Product Change Notice (PCN)

Subject: Addition of back-end production for general-purpose linear IC products (MSOP package products)

Publication Date: 6/30/2023

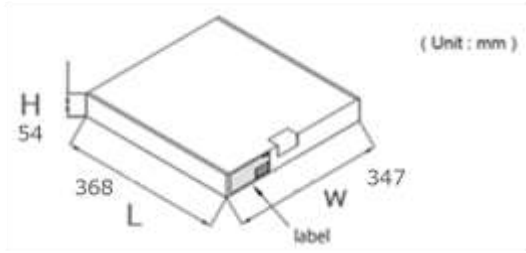
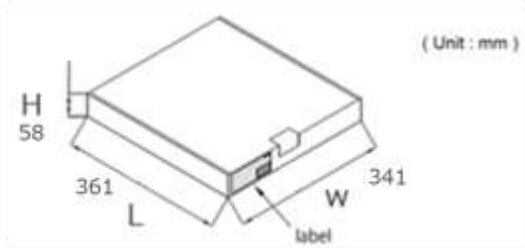
There are some dimensional differences in the outline drawing, but the recommended foot pattern remains the same.

Current products		(UNIT:mm)		HCA products		(UNIT:mm)	
ITEM	DIMENSION	ITEM	DIMENSION	ITEM	DIMENSION	ITEM	DIMENSION
D	2.90	D	2.75	D	2.95±0.20	D	2.75
D1	3.00±0.20	D1	3.00±0.20	D1	2.95±0.20	D1	2.95±0.20
E	2.80	E	2.80	E	2.80	E	2.80
HE	4.00±0.20	HE	4.00±0.20	HE	4.00±0.30	HE	4.00±0.30
e	0.65	e	0.65	e	0.65	e	0.65
b	0.22±0.05	b	0.22±0.05	b	0.20 ^{+0.10} _{-0.05}	b	0.20 ^{+0.10} _{-0.05}
A	1.03 MAX	A	1.03 MAX	A	1.00 MAX	A	1.00 MAX
A1	0.08±0.05	A1	0.08±0.05	A1	0.05±0.05	A1	0.05±0.05
A2	0.85±0.05	A2	0.85±0.05	A2	0.85±0.10	A2	0.85±0.10
A3	0.25	A3	0.25	A3	0.25	A3	0.25
L1	0.60±0.20	L1	0.60±0.20	L1	0.60±0.20	L1	0.60±0.20
c	0.145 ^{+0.05} _{-0.03}	c	0.145 ^{+0.05} _{-0.03}	c	0.13 ^{+0.10} _{-0.05}	c	0.13 ^{+0.10} _{-0.05}
Lp	0.37±0.10	Lp	0.37±0.10	Lp	0.37±0.12	Lp	0.37±0.12
x	0.10	x	0.10	x	0.10	x	0.10
y	0.10	y	0.10	y	0.10	y	0.10
θ	3° ^{+5°} _{-3°}	θ	3° ^{+5°} _{-3°}	θ	7±7°	θ	7±7°
ZD	0.525	ZD	0.525	ZD	0.50	ZD	0.50

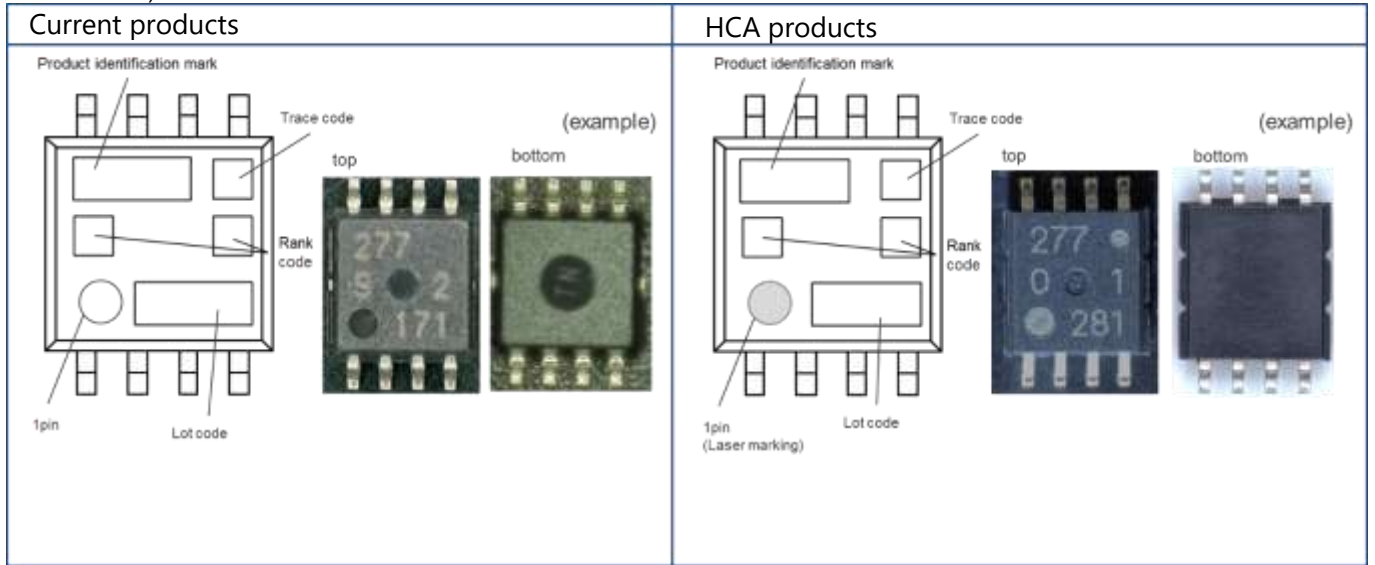
The appearance of the marking/outline (typeface, 1-pin mark, surface finish, etc.) is different, but the marking/outline information is the same. (There is no change in the marking drawing of the delivery specification.)

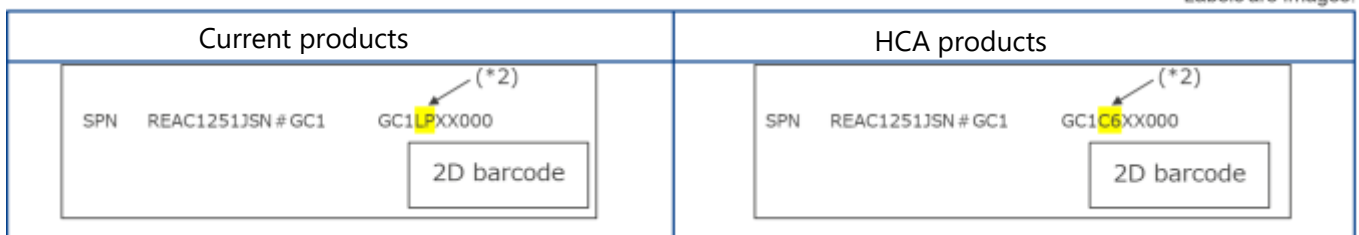
Production sites can be identified by labels (reels, packaging boxes).

Examples of products beginning with UPC
 (*1) characters: 04 → RG

Examples of products beginning with REAx
 (*2) characters: LP → C6
